UNITED STATES PATENT AND TRADEMARK OFFICE

| APPLICATION NO. | FILING DATE | FIRST NAMED INVENTOR | ATTORNEY DOCKET NO. | CONFIRMATION NO. |
|-----------------|-------------|----------------------|---------------------|------------------|
| 10/765,240 | 01/26/2004 | Randall M. Marich | GP-302177 | 1775 |

- 1) ☒ Responsive to communication(s) filed on 25 May 2006.
2a) ☒ This action is **FINAL**. 2b) ☐ This action is non-final.
3) ☐ Since this application is in condition for allowance except for formal matters, prosecution as to the merits is closed in accordance with the practice under *Ex parte Quayle*, 1935 C.D. 11, 453 O.G. 213.

Low cost shipping cover and rock guard for vehicle transmissions

FIG. 7

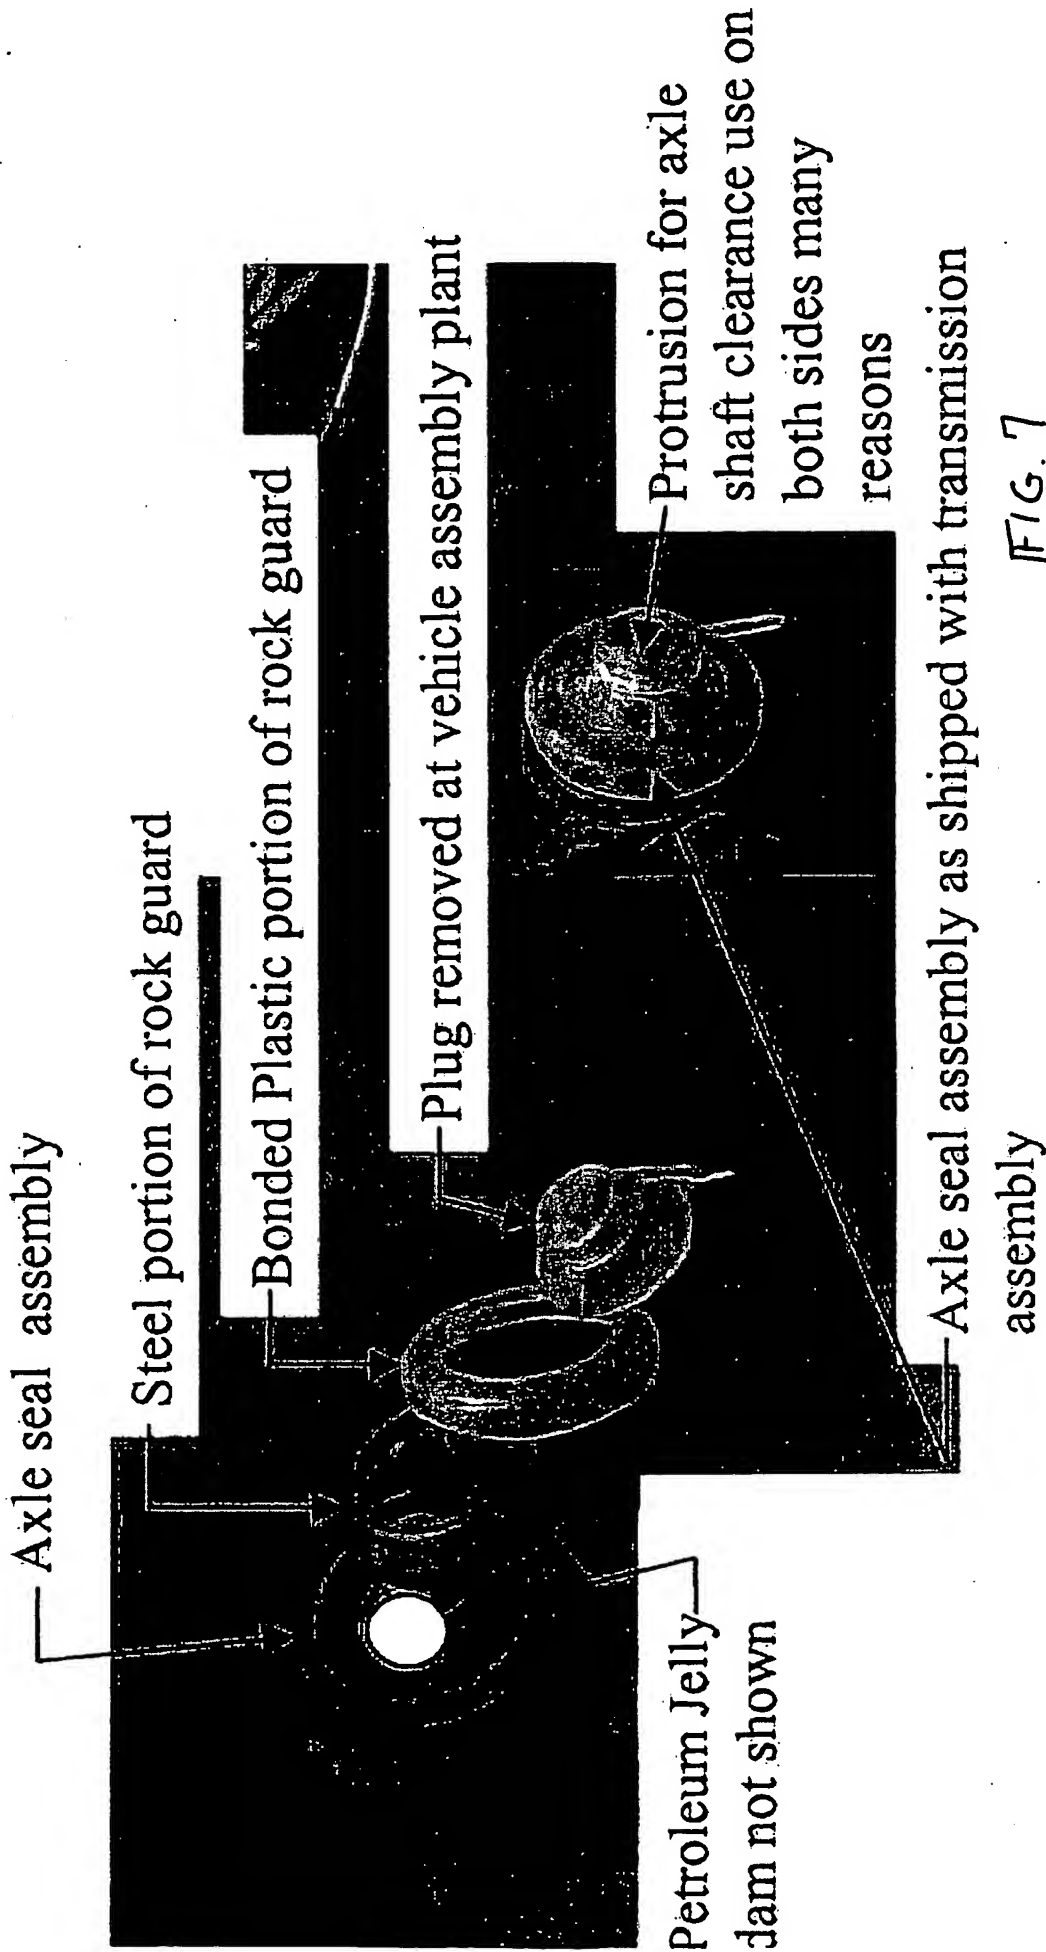
3. The drawings are objected to under 37 CFR 1.83(a). The drawings must show every feature of the invention specified in the claims. Therefore, the guard plate including a plurality of apertures having portions of the shield positioned in the apertures must be shown or the feature(s) canceled from the claim(s). No new matter should be entered.

The specification does not disclose that the shield has portions positioned in the apertures of the guard plate. The new drawing 7 does not clearly show the device, and it cannot be determined if the drawing is a photograph, which if it is, is not of sufficient quality so that all the details are reproducible. See MPEP 37 CFR 1.84.
